UNITED STATES
DEPARTMENT OF THE INTERIOR
BUREAU OF LAND MANAGEMENTFORM APPROVED
OMB NO. 1004-0135
Expires: November 30, 2000**SUNDRY NOTICES AND REPORTS ON WELLS**
*Do not use this form for proposals to drill or to re-enter an abandoned well. Use form 3160-3 (APD) for such proposals.***SUBMIT IN TRIPLICATE - Other instructions on reverse side.**

**** BLM REVISED ** BLM REVISED ** BLM REVISED ** BLM REVISED ** BLM REVISED ****

PLUG AND ABANDONMENT PROCEDURE

Florance Federal #3

Proposed P&A

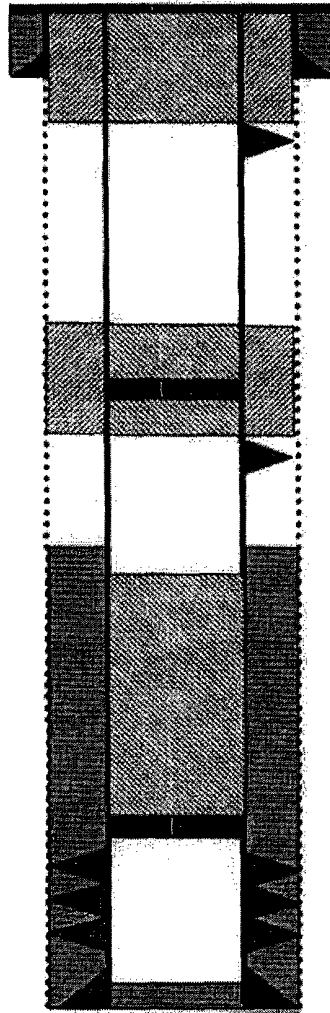
4. Plug #2 (Nacimiento top, ²²²¹1850' – ²¹²¹1750'): Perforate 3 squeeze holes at ²²²¹1850'. Attempt to establish rate into squeeze holes if the casing pressure tested prior to perforating. Set 4.5" cement retainer at 1850'. Establish rate into squeeze holes. Mix and pump 32 sxs cement, squeeze 21 sxs outside the casing and leave 11 sxs inside casing to cover Nacimiento top. TOH and LD tubing.

2221 2121
